UNITED STATES PATENT AND TRADEMARK OFFICE

APPLICATION NO.	FILING DATE	FIRST NAMED INVENTOR	ATTORNEY DOCKET NO.	CONFIRMATION NO.
10/620,575	07/17/2003	Jang-Jin Yoo	8733.418.10	8871

Office Action Summary

DETAILED ACTION

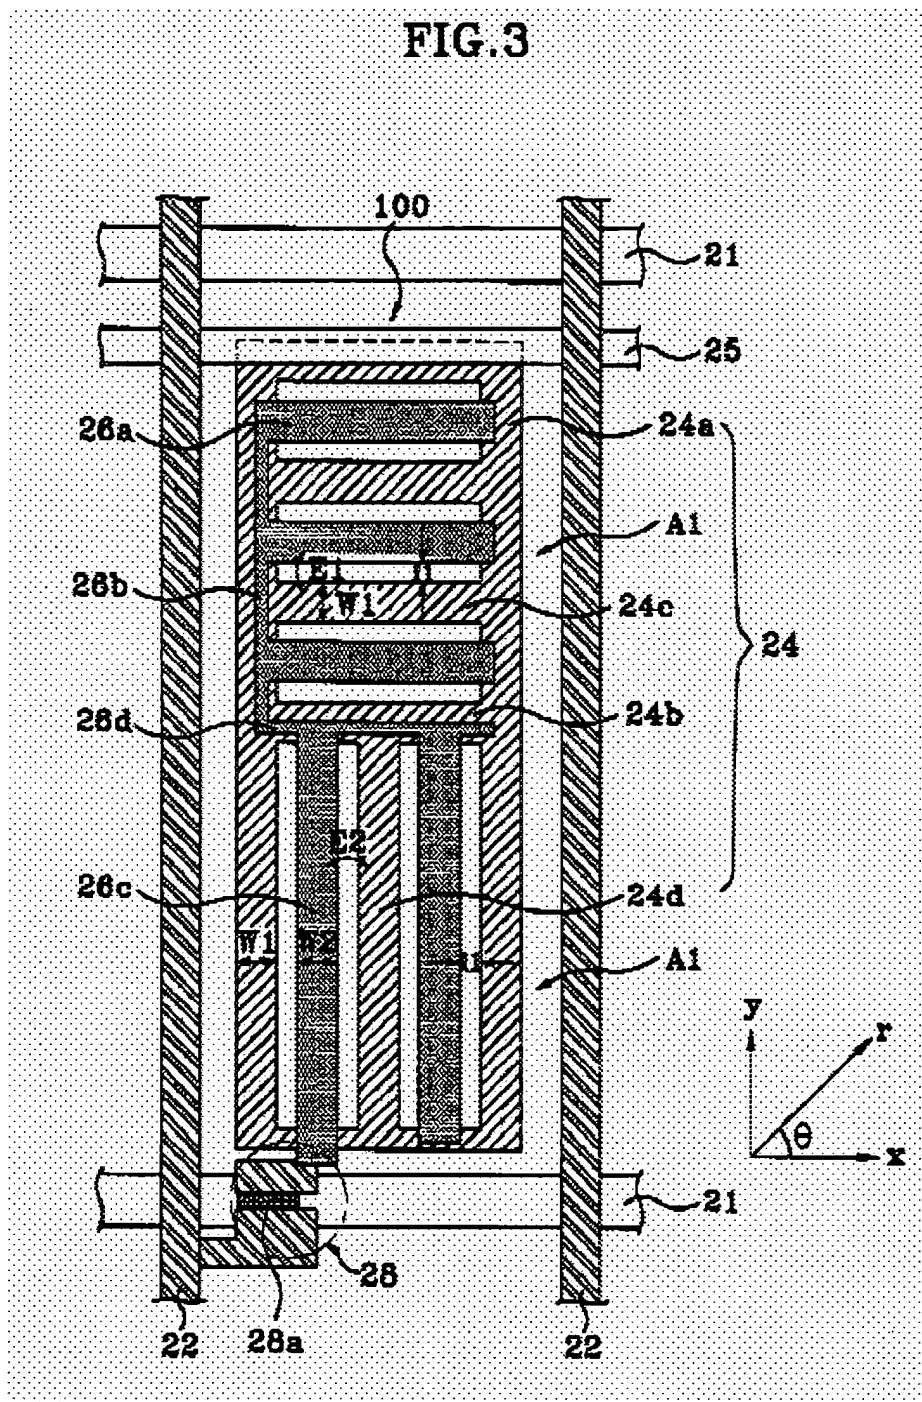
3. Claims 18-20 are rejected under 35 U.S.C. 102(e) as being anticipated by Lee et al (Lee) USPAT 6,266,118 B1.

As to claim 18, Lee discloses (Abstract, Title, entire patent and first embodiment) an array substrate for an IPS-LCD device (col. 6, line 35 through col. 9, line 54), comprising:

a substrate; a gate line, 21, on the substrate; a data line, 22, perpendicular to the gate line; a thin film transistor, 28, at a crossing portion between the gate and data lines; a common line, 25, parallel to the gate line; a plurality of common electrodes, 24a, and its

counterpart on the left, extending perpendicular to the common line, the plurality of common electrodes being divided into first and second portions of respective first and second domains [multiple common electrode portions in upper and lower domains]; a plurality of pixel electrodes, 26c and 26b, arranged alternately with the plurality of common electrodes, the plurality of pixel electrodes being divided into first and second portions of the respective first and second domains [multiple pixel electrode portions in upper and lower domains]; an auxiliary common electrode, 24c, perpendicularly contacting each of the common electrodes; and an auxiliary pixel electrode, 26d, perpendicularly contacting each of the pixel electrodes; wherein the auxiliary pixel electrode is spaced apart from the auxiliary common electrode; and the pixel electrodes are on a same layer as said auxiliary pixel electrode, and wherein the plurality of common electrodes have a portion, 24d, that does not continue all the way across the pixel region.

plurality of common electrodes, 24d, 24a, and its counterpart on the left, extending perpendicular to the common line; a plurality of pixel electrodes, 26c and its counterpart on the right, arranged alternately with the plurality of common electrodes; and a plurality of auxiliary electrodes, 24b, 24c, and 26d, connecting the plurality of common and pixel electrodes to form a multi-domain having a checkered pattern.

1) It is respectfully pointed out that the present broad claim language allows the presently applied prior art to read on the claims per rejections above. Please note that item 24c contacts each of 24a and its counterpart on the left in Figure 3. Existence of other electrodes is permitted because the claims are in comprising format.

**FIG. 10**

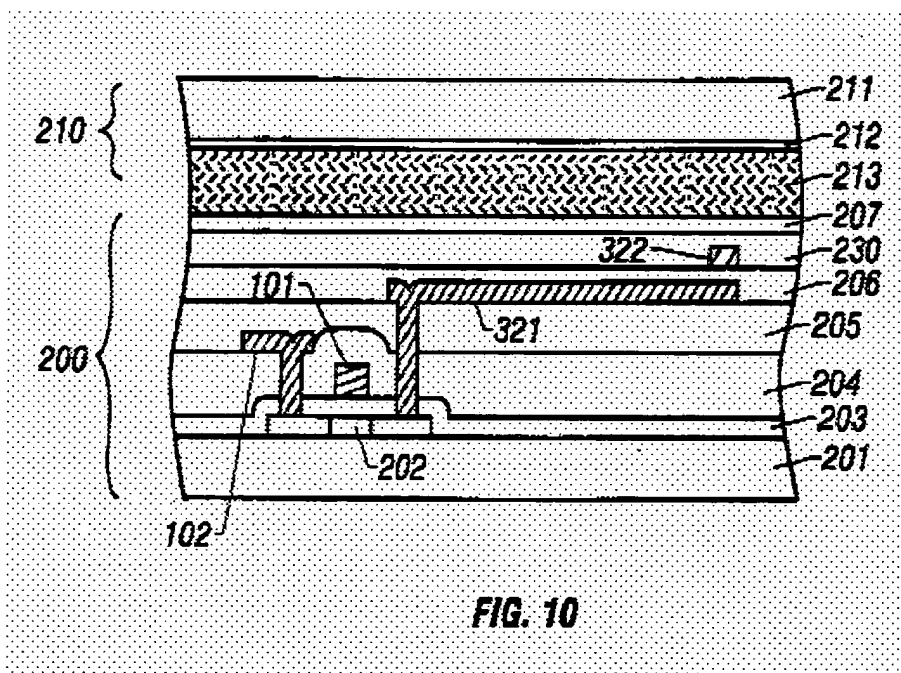
Hirakata teaches in the fourth embodiment (col. 8, line 56 through col. 9, line 34) a dielectric film, 205 (Applicant's first passivation layer), over the gate insulating layer, the data line and thin film transistor; a plurality of pixel electrodes, 321, on the first passivation layer; a second dielectric film, 206 (Applicant's second passivation layer), over the pixel electrodes; a common line, 322, on the second passivation layer to comprise a structure with increased aperture ratio (col. 8, lines 57-59).

Hirakata is evidence that ordinary workers in the art of liquid crystals would find the reason, suggestion, or motivation to add a first passivation layer over the gate insulating layer, the data line and thin film transistor; a plurality of pixel electrodes on the first passivation layer; a second passivation layer over the pixel electrodes; a common line on the second passivation layer to comprise a structure with increased aperture ratio.

Therefore, it would have been obvious to one having ordinary skill in the art of liquid crystals at the time the invention was made to modify the LCD of Lee with the first passivation layer over the gate insulating layer, the data line and thin film transistor; a plurality of pixel electrodes on the first passivation layer; a second passivation layer over the pixel electrodes; a common line on the second passivation layer of Hirakata to comprise a structure with increased aperture ratio.

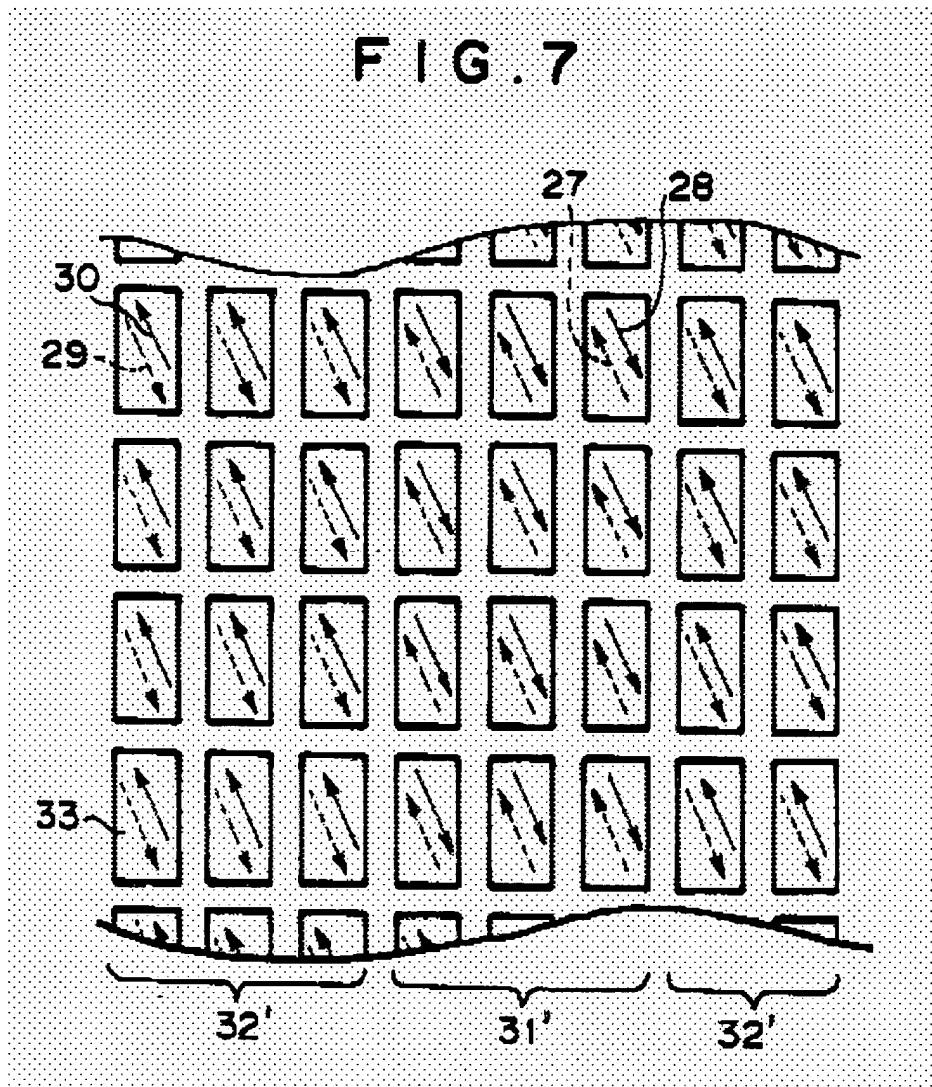
Hirakata teaches in the fourth embodiment (col. 8, line 56 through col. 9, line 34) a dielectric film, 205 (Applicant's first passivation layer), over the gate insulating layer, the data line and thin film transistor; a plurality of pixel electrodes, 321, on the first passivation layer; a second dielectric film, 206 (Applicant's second passivation layer), over the pixel electrodes; a common line, 322, on the second passivation layer to comprise a structure with increased aperture ratio (col. 8, lines 57-59).

Hirakata is evidence that ordinary workers in the art of liquid crystals would find the reason, suggestion, or motivation to add a first passivation layer over the gate insulating layer, the data line and thin film transistor; a plurality of pixel electrodes on the first passivation layer; a second passivation layer over the pixel electrodes; a common line on the second passivation layer to comprise a structure with increased aperture ratio.

Therefore, it would have been obvious to one having ordinary skill in the art of liquid crystals at the time the invention was made to modify the LCD of Lee with the first passivation layer over the gate insulating layer, the data line and thin film transistor; a plurality of pixel electrodes on the first passivation layer; a second passivation layer over the pixel electrodes; a common line on the second passivation layer of Hirakata to comprise a structure with increased aperture ratio.

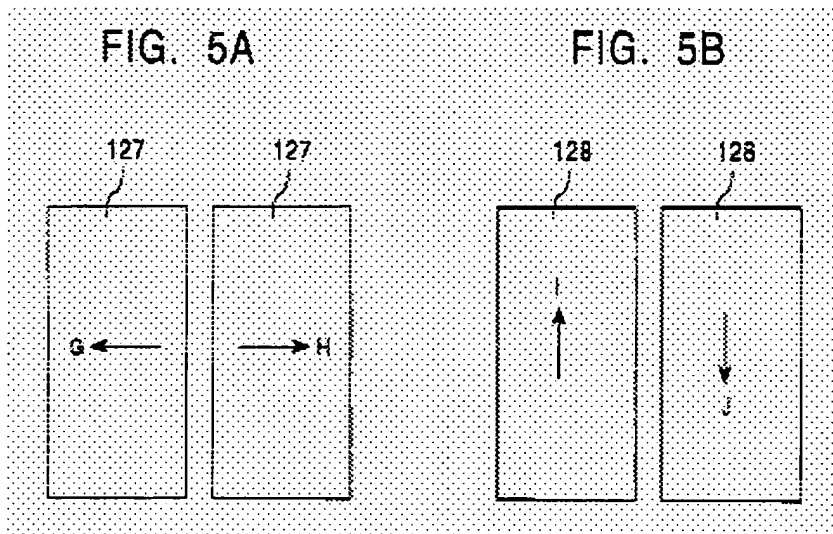
Chen teaches (Abstract, Title, entire patent, Figures 5A and 5B) an alignment layer having first and second rubbing directions, the first and second rubbing directions corresponding to the first and second domains, respectively to enhance image quality by preventing dependence on the viewing angle in the vertical and right-and-left directions with a process as simple as possible [abstract].

Please note that one of the two illustrated arrangements of Chen would be symmetrical about a line parallel to the gate line regardless of whether the gate line runs up and down, or left and right.
